APP/15/00885

PLAN-010976

**Proposal: Construction of 1No. 2 bed two storey end of terrace house with
associated parking and vehicular access from Shawford Grove.
Site: 32 Ramsdale Avenue, Havant, PO9 4DZ.
APP/15/00885**

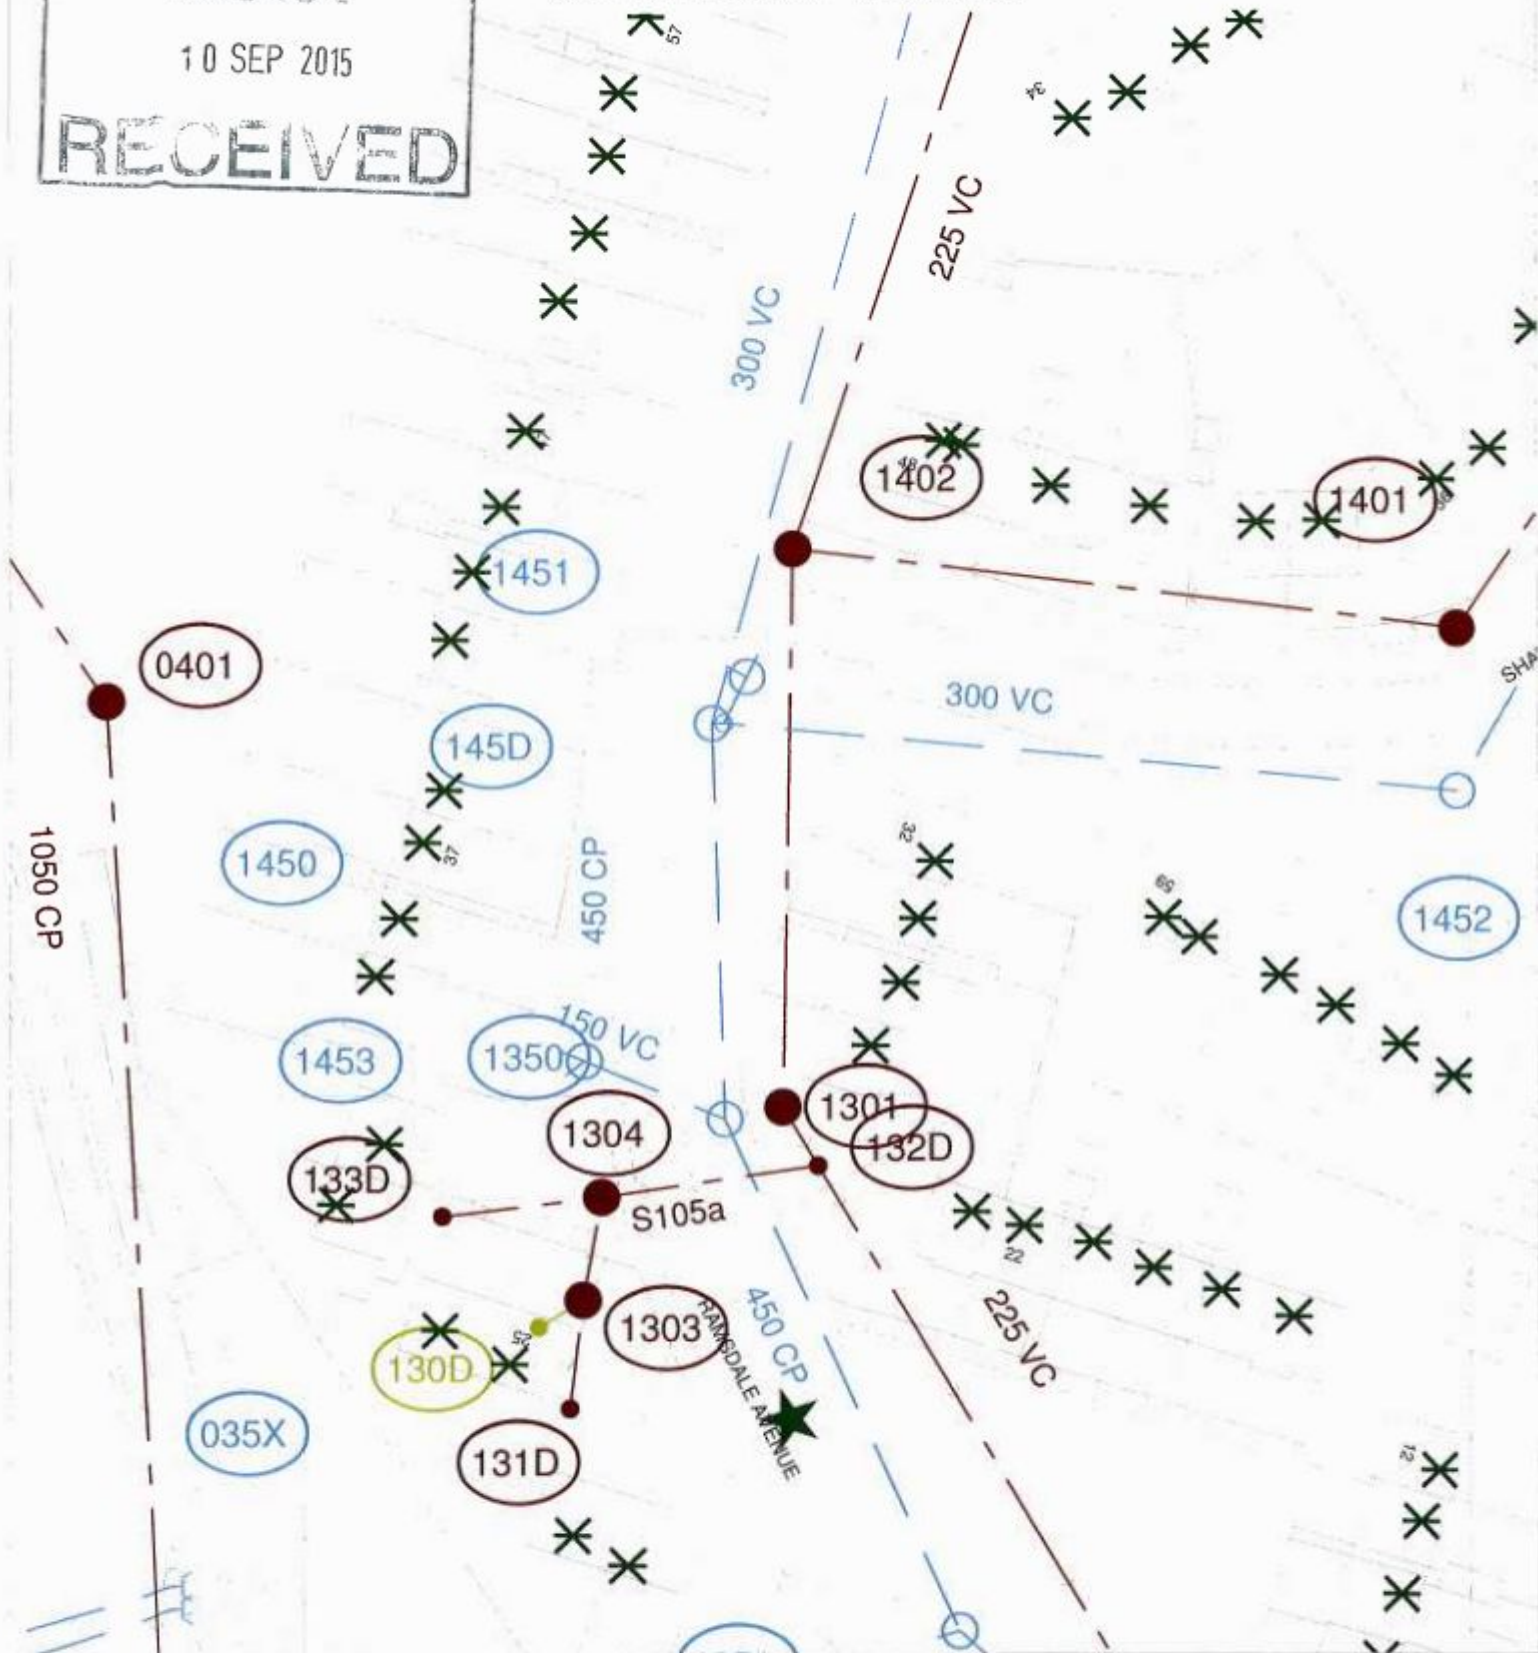
Please find attached a plan of the sewer records showing the approximate position of a public surface water sewer crossing the site. The exact position of the public sewers must be determined on site by the applicant before the layout of the proposed development is finalised.

1. The 300 mm diameter sewer requires a clearance of 3 metres either side of the sewer to protect it from construction works and allow for future access for maintenance.
2. No development or new tree planting should be located within 3 metres either side of the centreline of the public sewer
3. No new soakaways should be located within 5 metres of a public sewer.
